S.N. 09/813,205
Art Unit 2862
Atty Dkt 10013284-1

REMARKS

FIG. 8

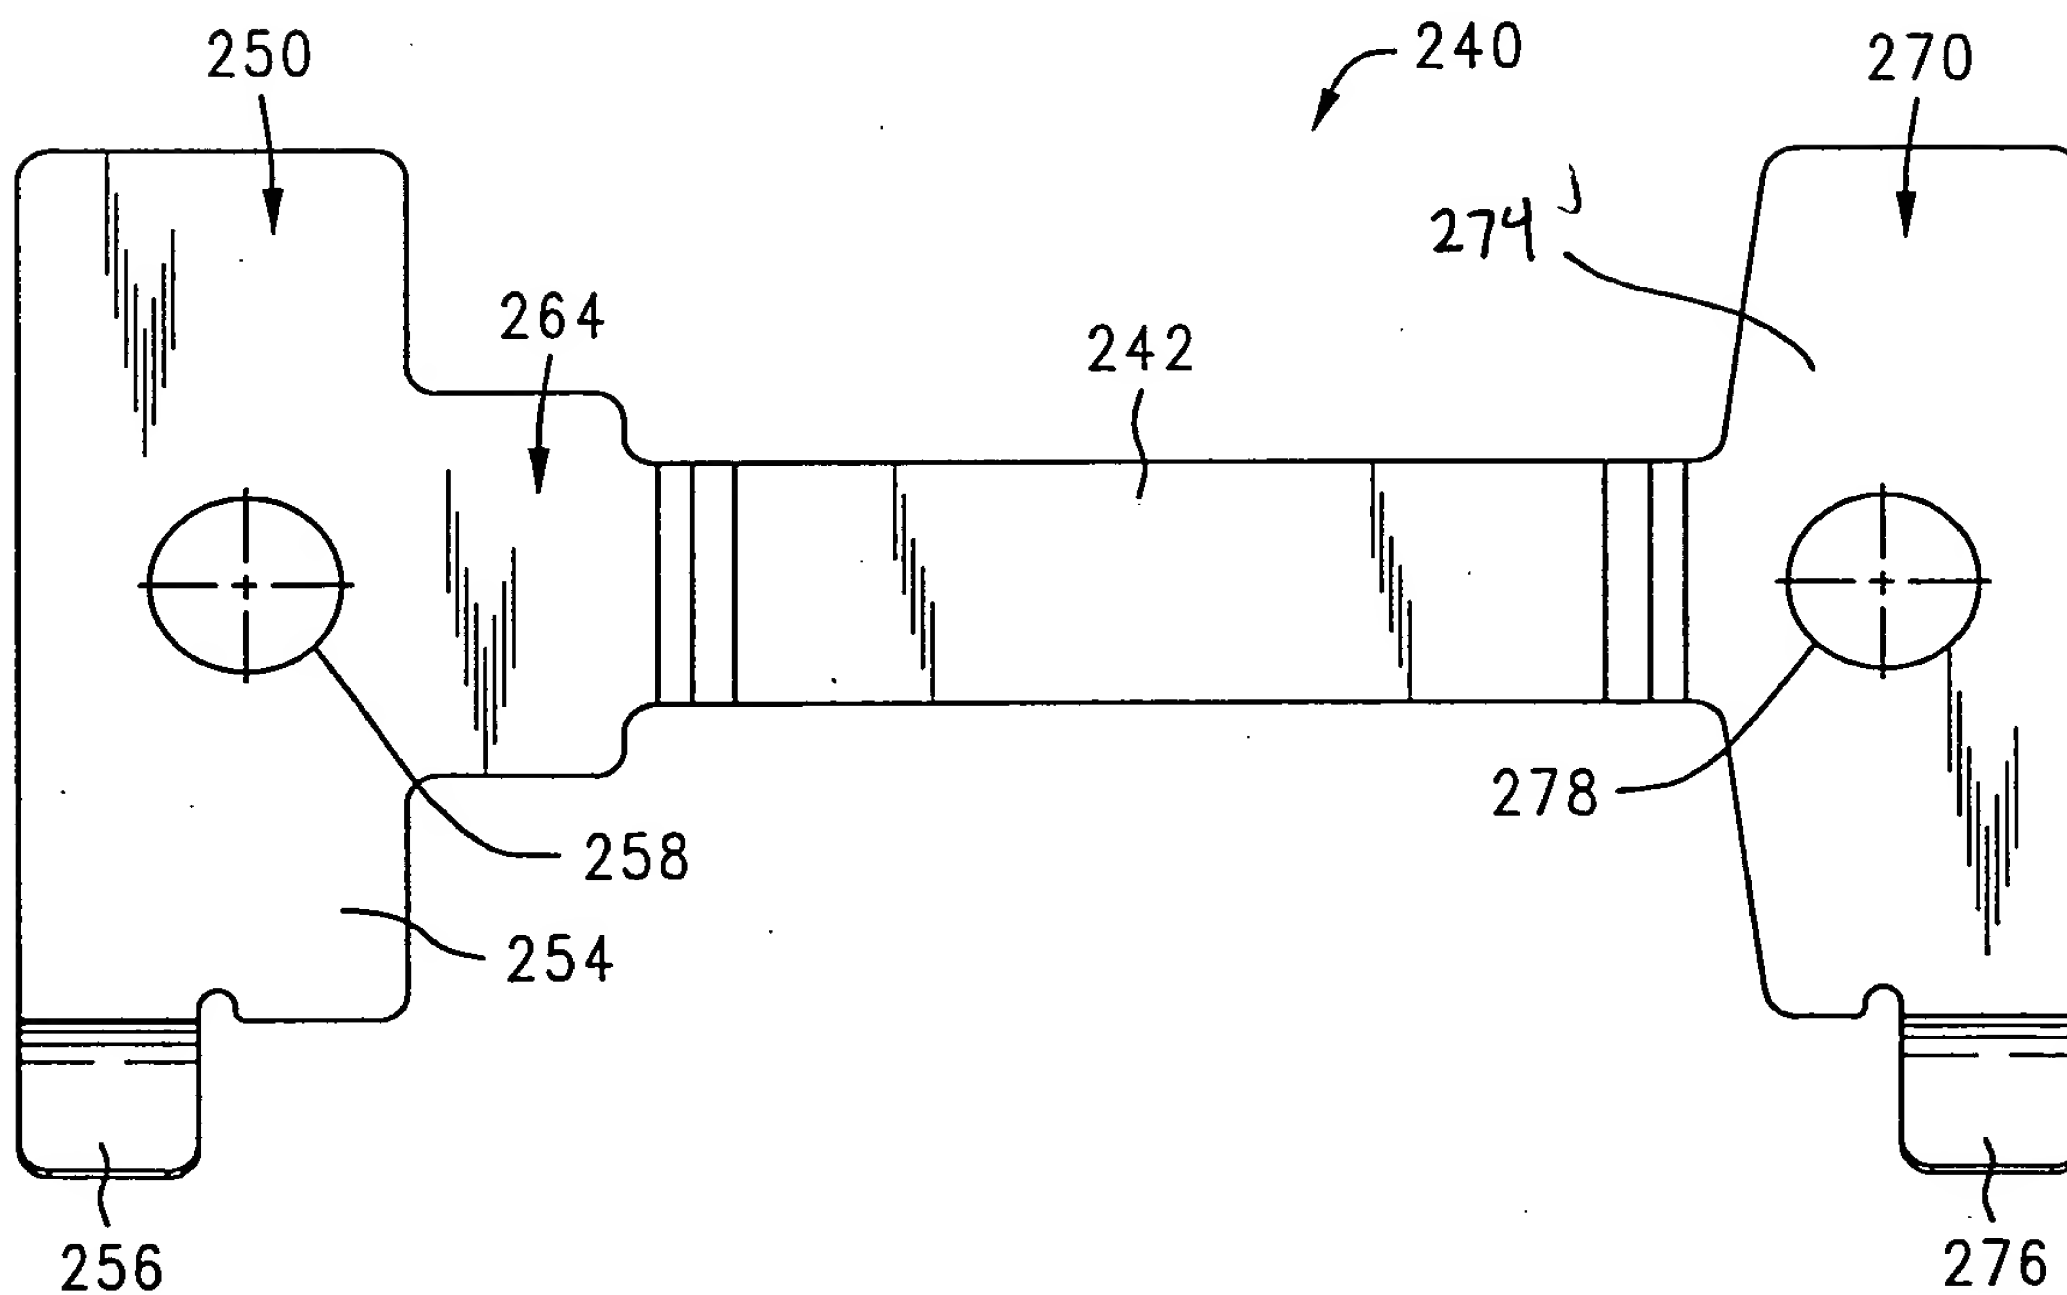
The Examiner notes that the reference numeral "274" is not shown in Fig. 8. In response, applicants have amended Fig. 8 to add reference numeral 274.

FIG. 9

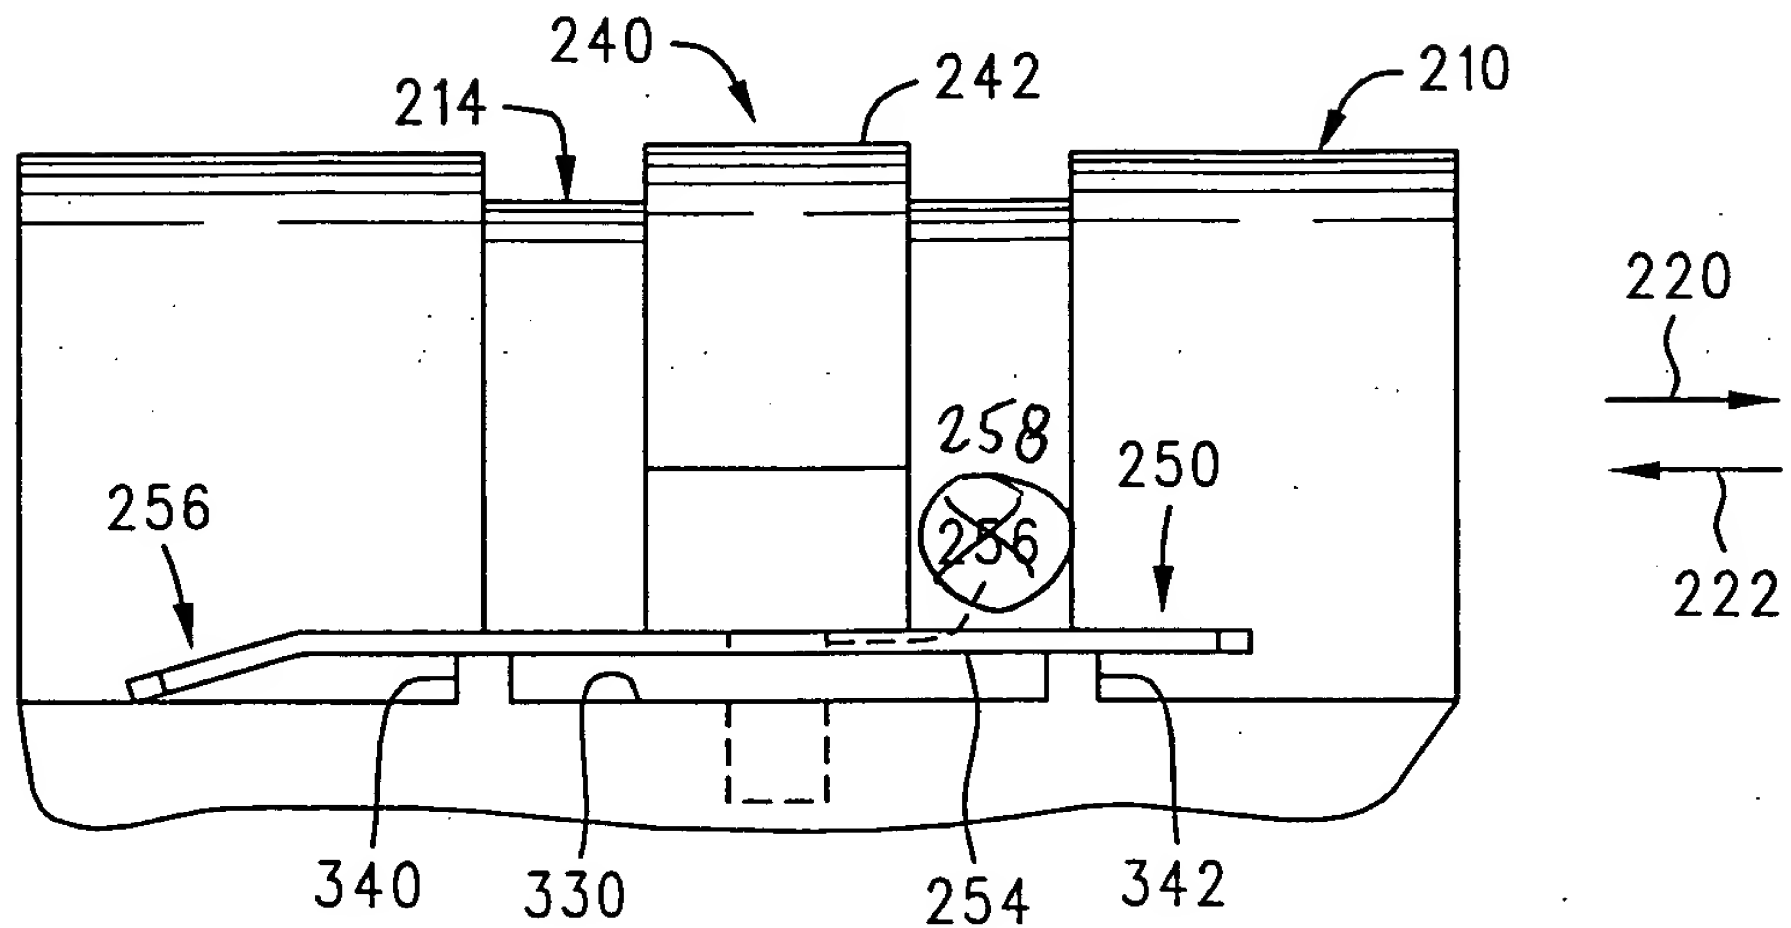
Applicants have also amended Fig. 9 herein to correct a minor error appearing therein. Specifically, the reference numeral "256" denotes two features in the drawing. Fig. 9 has been amended to denote the hole with reference numeral "258" instead of "256"
